## Planning Commission Staff Report

**Petition:** **P.Z. 18-2016 17511 Chesterfield Airport Road (Palio Partners)**: A request for a zoning map amendment from an “NU” Non-Urban District to a “PC” Planned Commercial District for a 13.01 acre tract of land located north of Chesterfield Airport Road, east of Long Road, west of Arnage Blvd, and south of Interstate 64/US 40 (17U510084).

RE: P.Z. 18-2016 17511 Chesterfield Airport Rd (Palio Partners) – Zoning Map Amendment NU to PC

PRELIMINARY PLAN  
17511 CHESTERFIELD AIRPORT ROAD  
CHESTERFIELD, MISSOURI

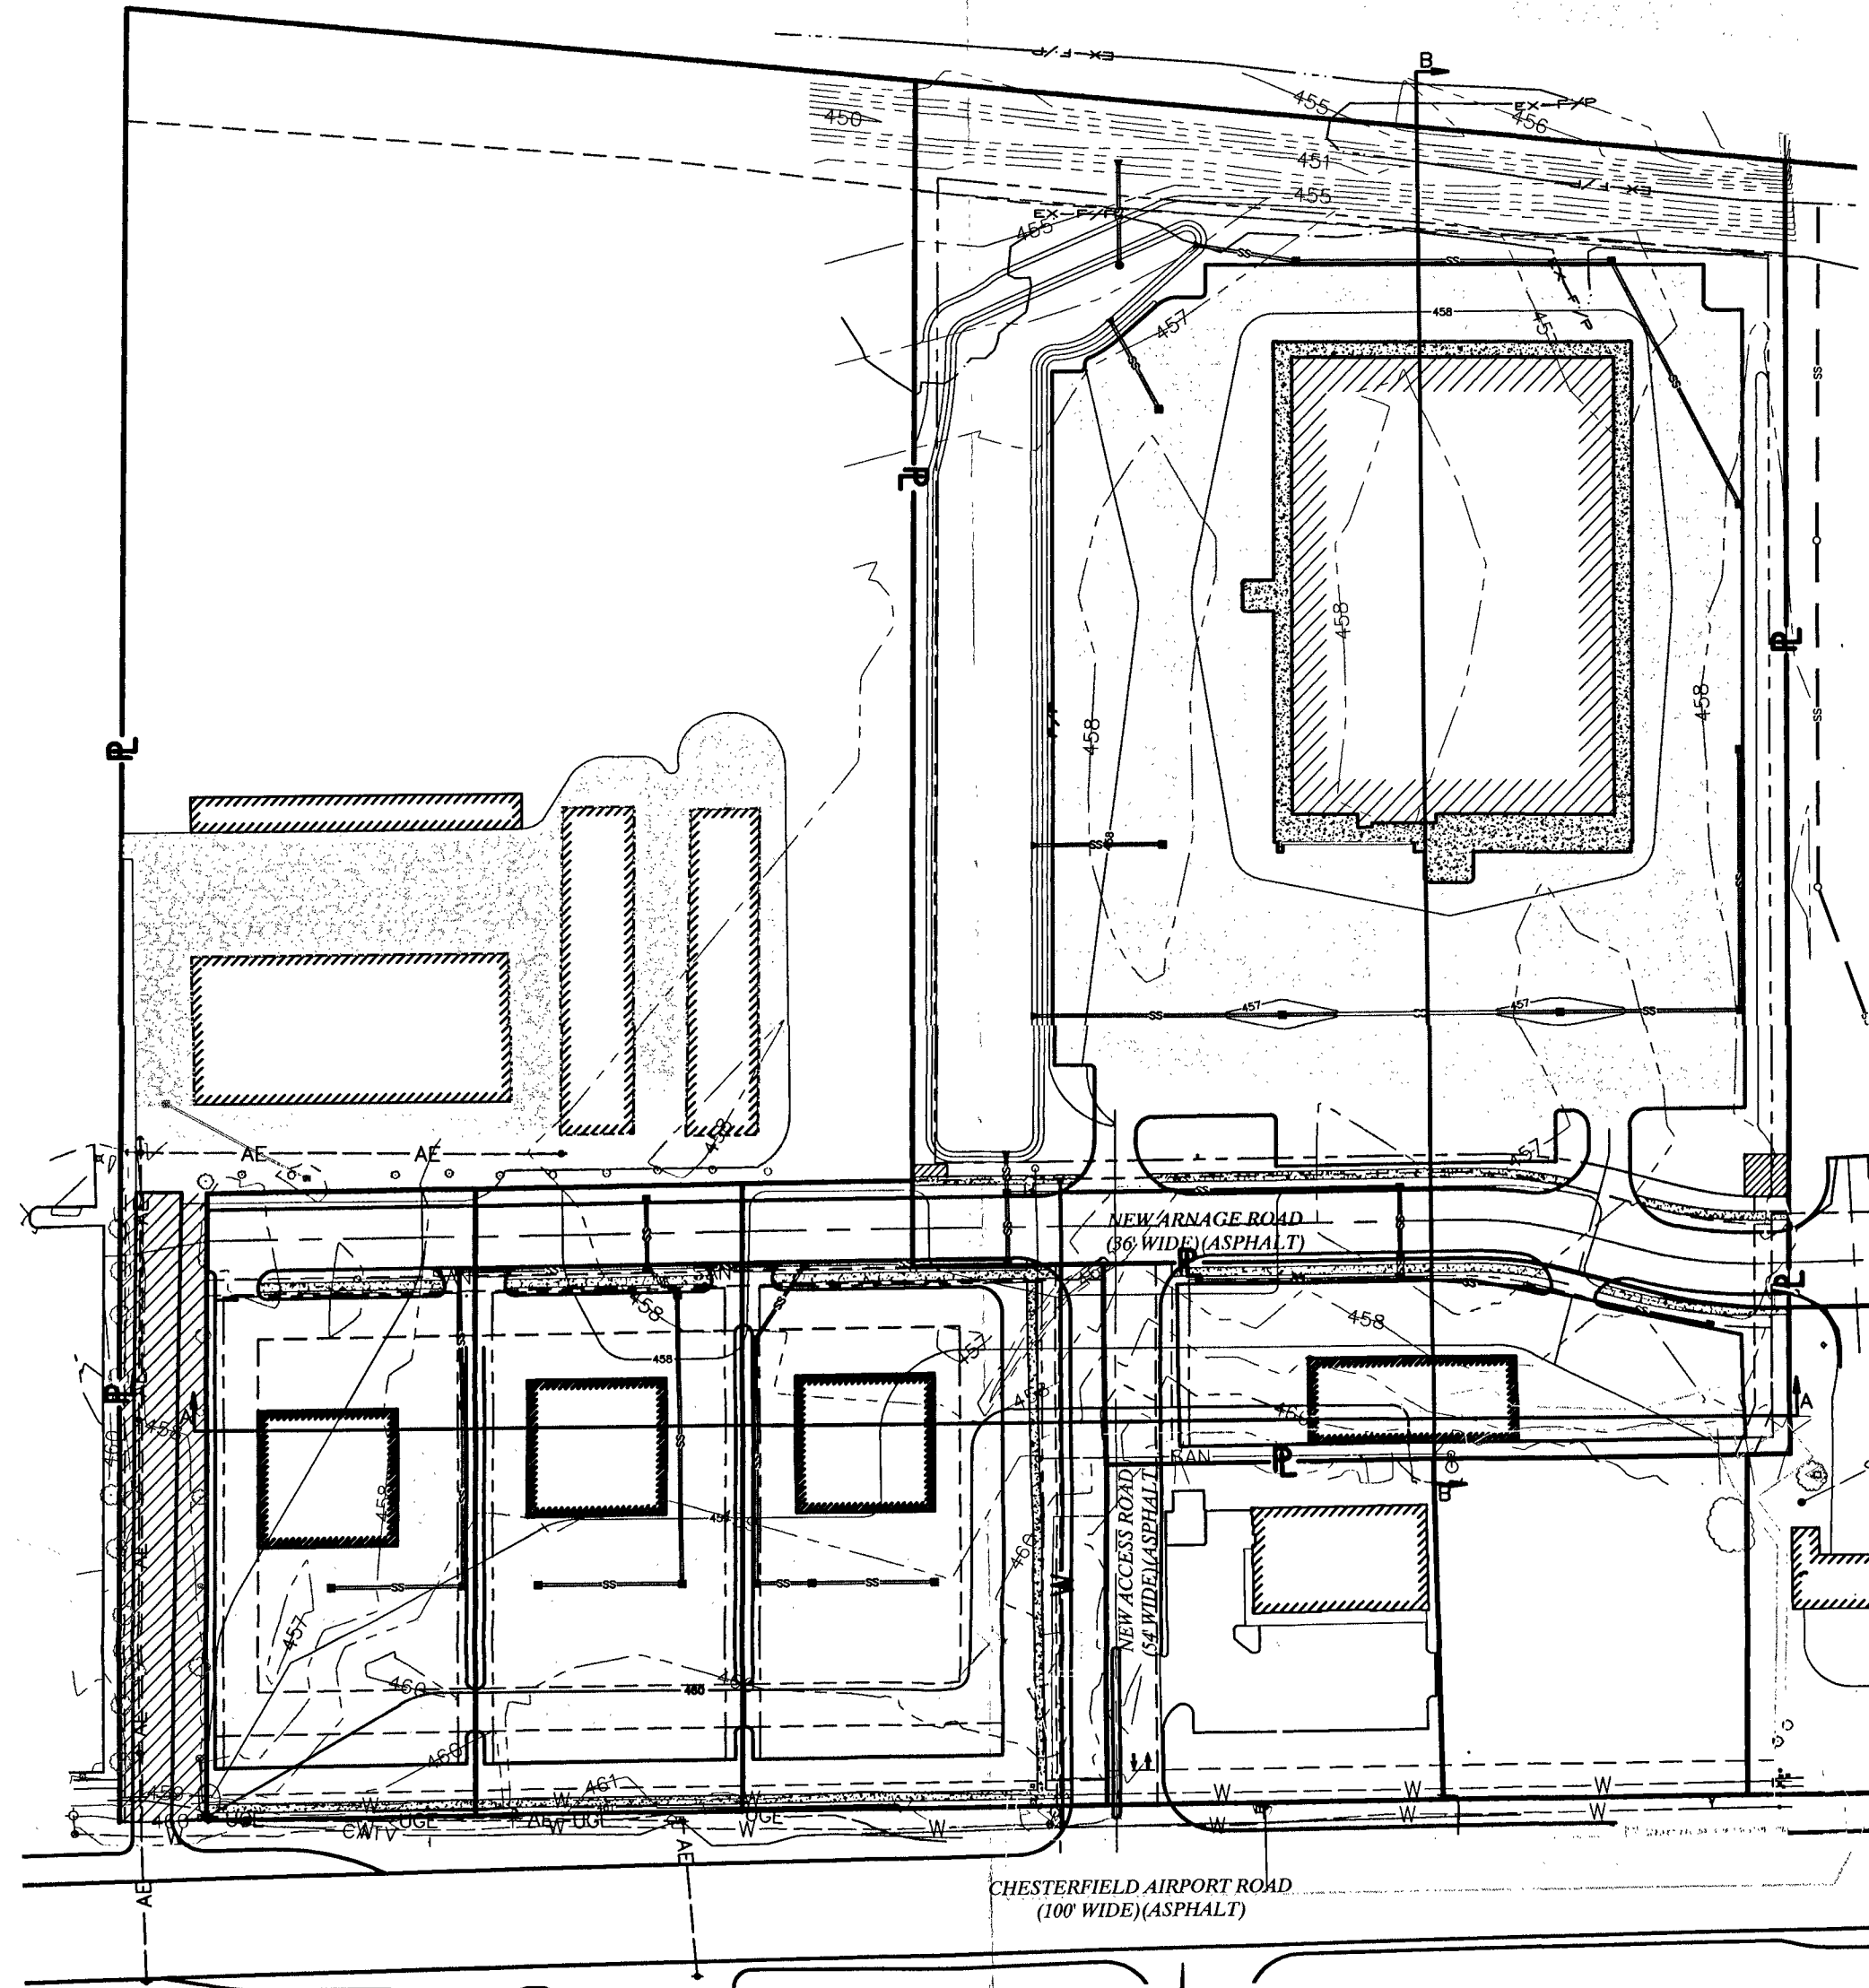
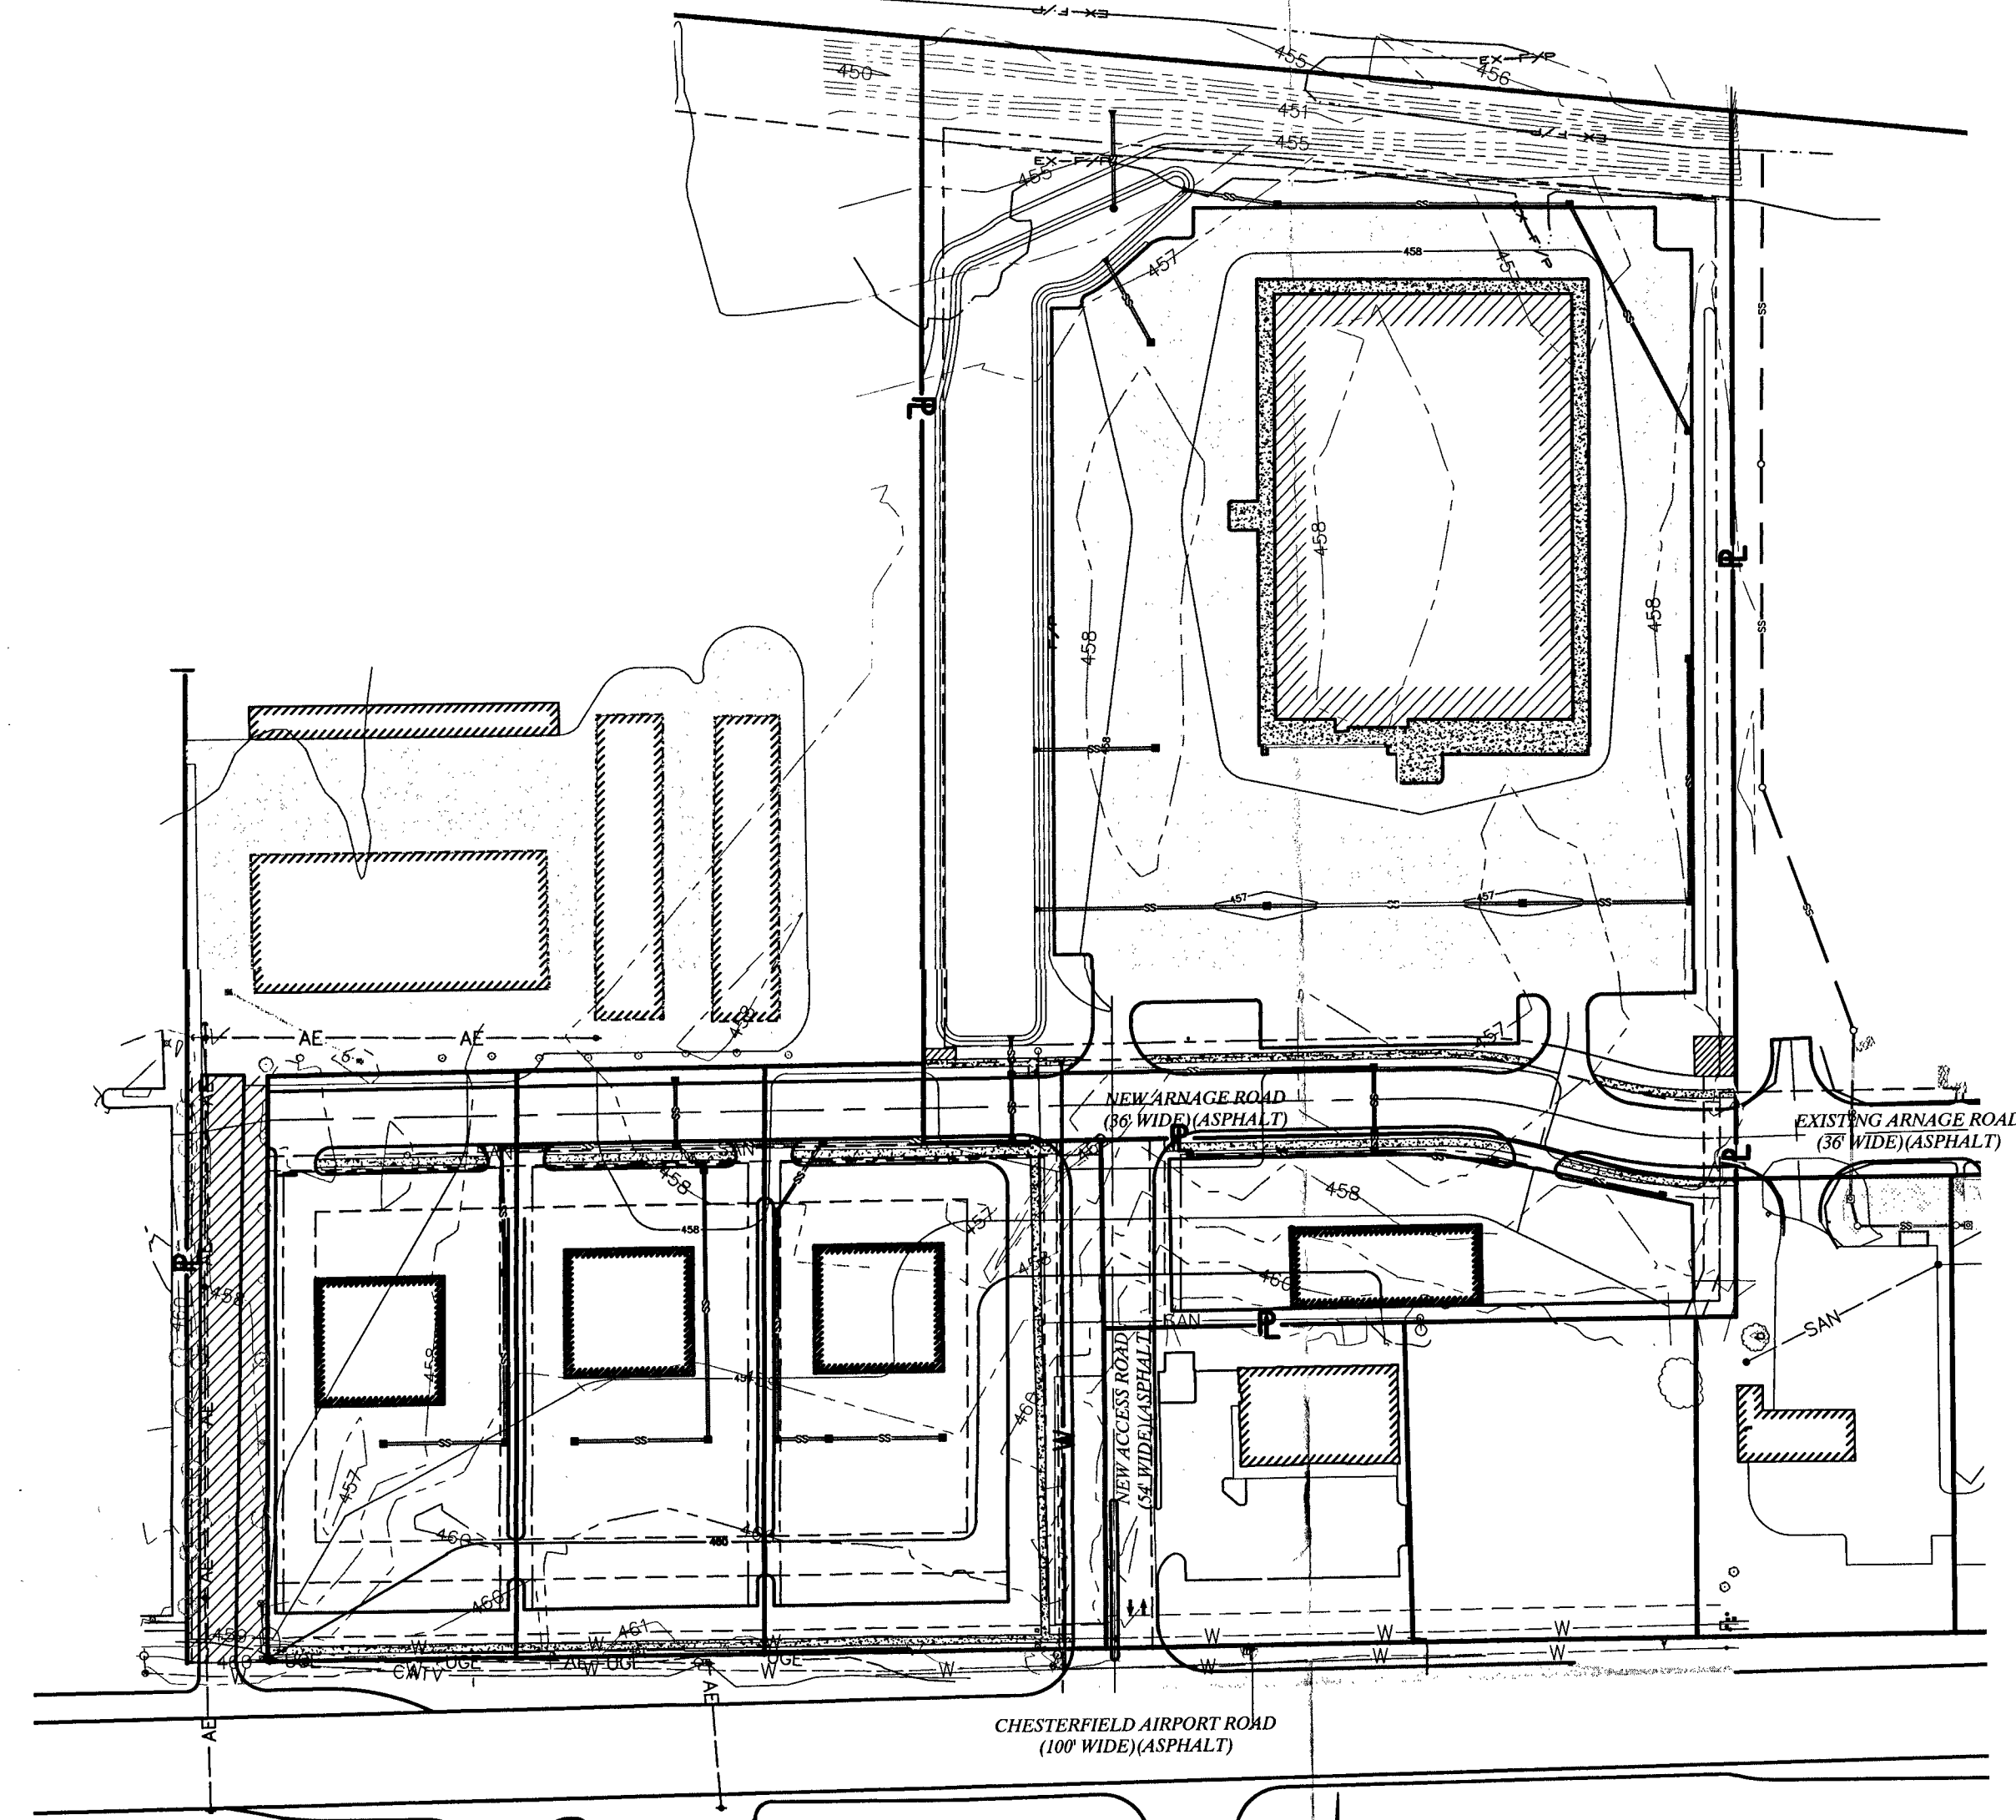
1. Revise the setback lines to reflect building and/or parking setback as opposed to side, rear, etc. **Preliminary Plan revised as requested.**
2. Remove the setback information from the legend; the Attachment A will indicate that setbacks are to be as shown on the Preliminary Plan. **Preliminary Plan revised as requested.**

3. Chesterfield Valley Master Plan channels are to be kept clear to ensure the storm water system can function properly. Show all trees and any other obstructions in the stormwater easement area as "To Be Removed" and omit existing trees in the channel from the woodland area calculations. **Note added as requested.**

4. Show the additional information for proposed and existing improvements within 150 feet of the site (e.g. existing topography, existing storm/sanitary sewers, location of existing 84 lumber buildings, driveway entrance locations on the south side of Chesterfield Airport Road, proposed AutoZone development, etc.) on Sheet 1 as well as Sheet 2. **Added as requested.**

5. Sidewalk is typically required on both sides of the road. However, it is understood that sidewalk was not required along the western side of the AutoZone development. Please add sidewalk across the frontage of Lot 1 on the north side of Arnage Road. Sidewalk along the north side of Arnage Road west of lot opposite Lots 2, 3, and 4 will be required in conjunction with future development. **Sidewalk added as requested.**

6. The eastern drive on Lot 1 and the drive for Lot 5 do not comply with the City's driveway access location and design standards. Please revise the access locations such that they are in compliance with the requirements which can be found in City Code Sec. 31-04-10. **Revised as requested.**

7. The temporary cul-de-sac proposed on Lot 2 presents some issues with the tree lawn area and width of the driveway entrance. Please revise the driveway access to Lot 2 to be a typical width entrance drive from the temporary turnaround and maintain the tree lawn area around the turn around. Alternatively, in accordance with City Code Section 31-04-09B.1.(l) it is acceptable to utilize a driveway as a temporary turnaround provided any easements necessary for the turnaround movement are in place and the property owner accepts the responsibility for any repairs necessary due to the turning movements. **In lieu of the temporary turn around, cross access has been provided and applicant accepts code above.**
